SALEM NUCLEAR GENERATING STATION, UNIT NO. 1

AMENDMENT TO FACILITY OPERATING LICENSE

Amendment No. 25
License No. DPR-70

SAFETY EVALUATION BY THE OFFICE OF NUCLEAR REACTOR REGULATION
RELATED TO AMENDMENT NO. 25 TO FACILITY OPERATING LICENSE NO. DPR-70

FIGURE 6.2-1. OFFSITE ORGANIZATION FOR FACILITY MANAGEMENT AND TECHNICAL SUPPORT

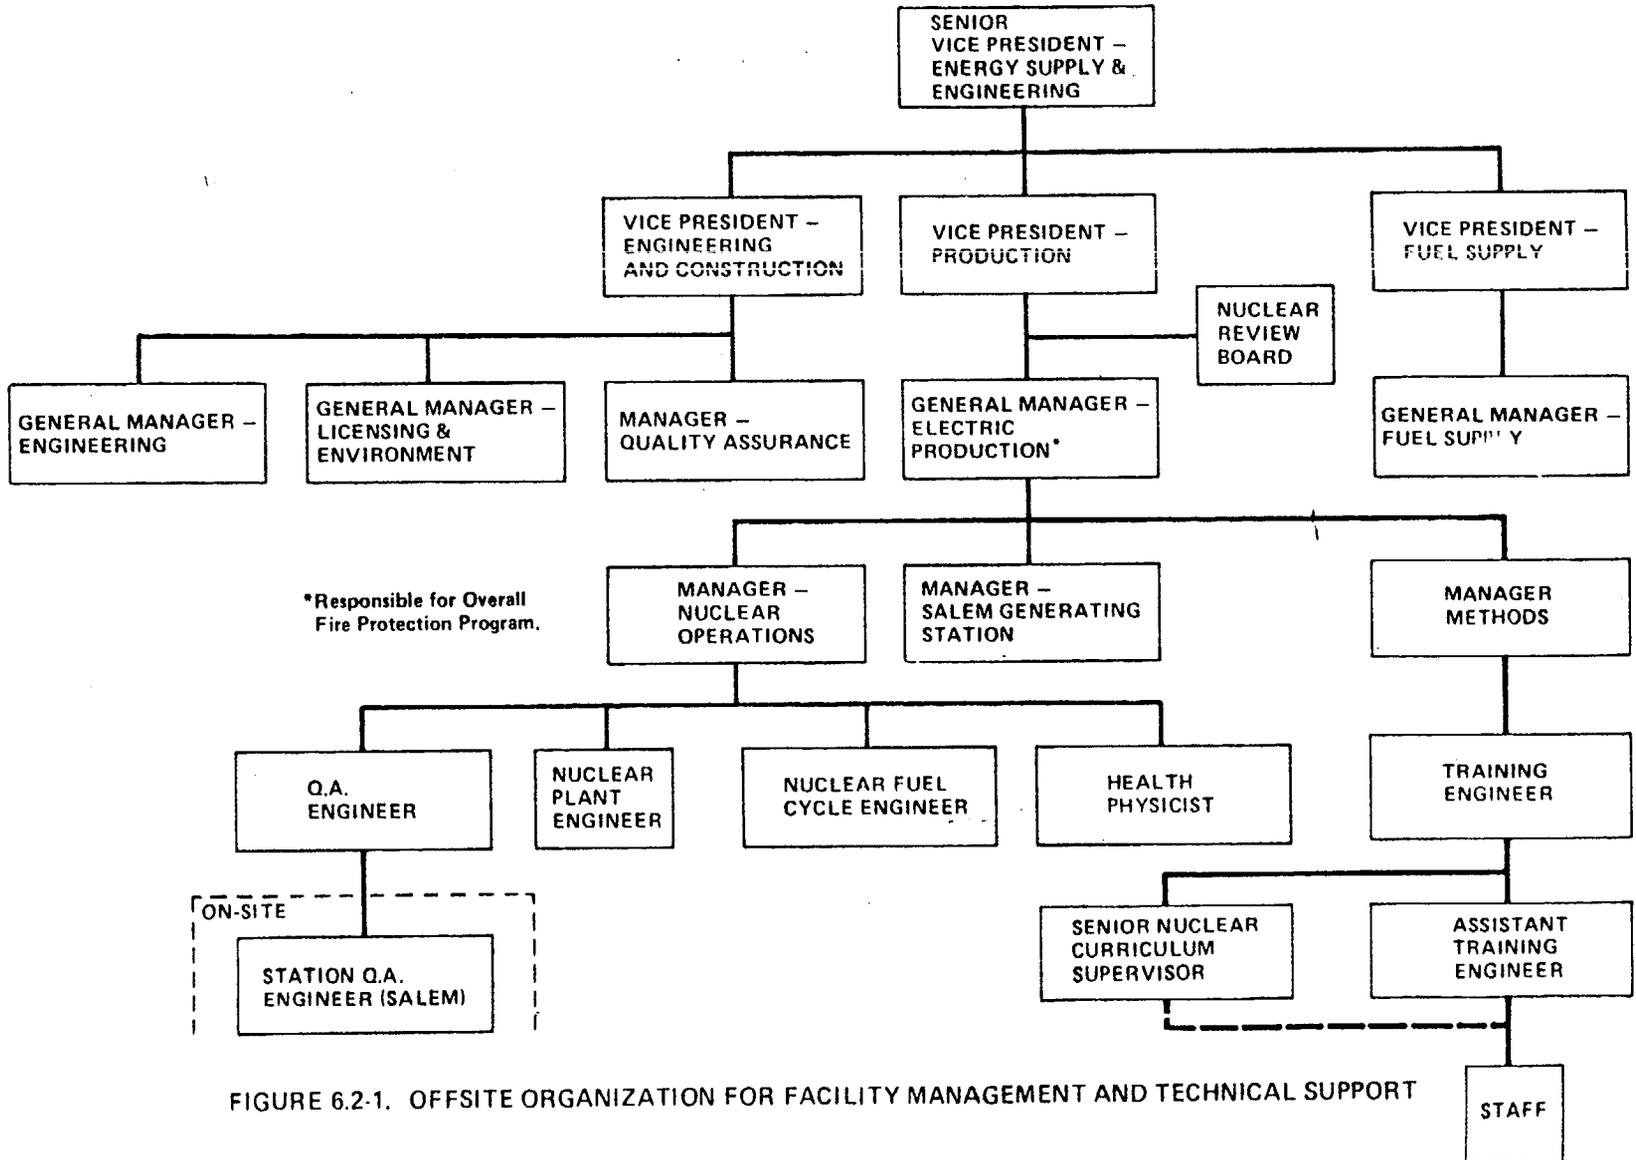
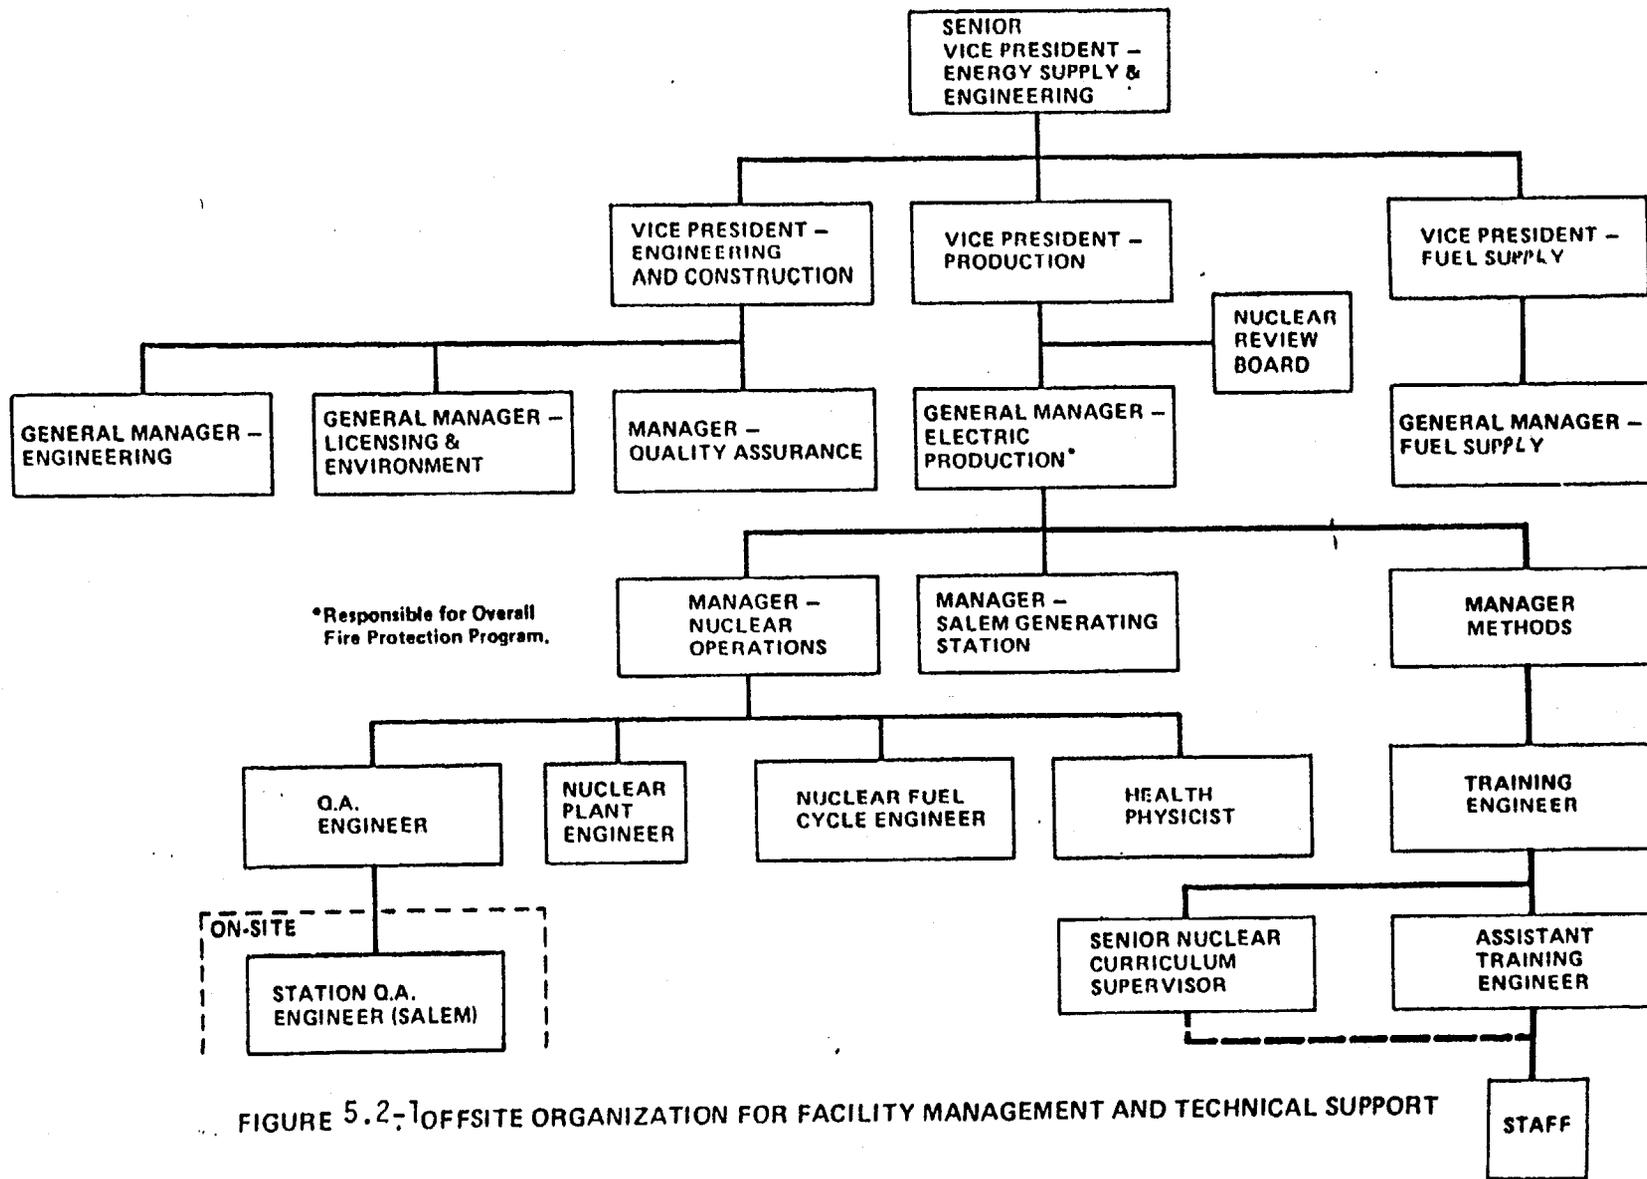
During our review we discussed with your staff further revisions in the presentation of the organizational figures in your January 28, 1979 letter. Your staff agreed to these changes and they have been incorporated into this amendment.

We have found that the three organizational changes are administrative in nature and, as such, do not decrease the overall effectiveness of the Nuclear Review Board, the Chemistry/Health Physics Performance Department, or the training organization. Instead, it is our belief that the changes in the Chemistry/Health Physics Department and in the training organization will strengthen the effectiveness of these parts of the Salem organization and are acceptable.

During our review we discussed with your staff further revisions in the presentation of the organizational figures in your January 28, 1979 letter. Your staff agreed to these changes and they have been incorporated into this amendment.

We have found that the three organizational changes are administrative in nature and, as such, do not decrease the overall effectiveness of the Nuclear Review Board, the Chemistry/Health Physics Performance Department, or the training organization. Instead, it is our belief that the changes in the Chemistry/Health Physics Department and in the training organization will strengthen the effectiveness of these parts of the Salem organization and are acceptable.
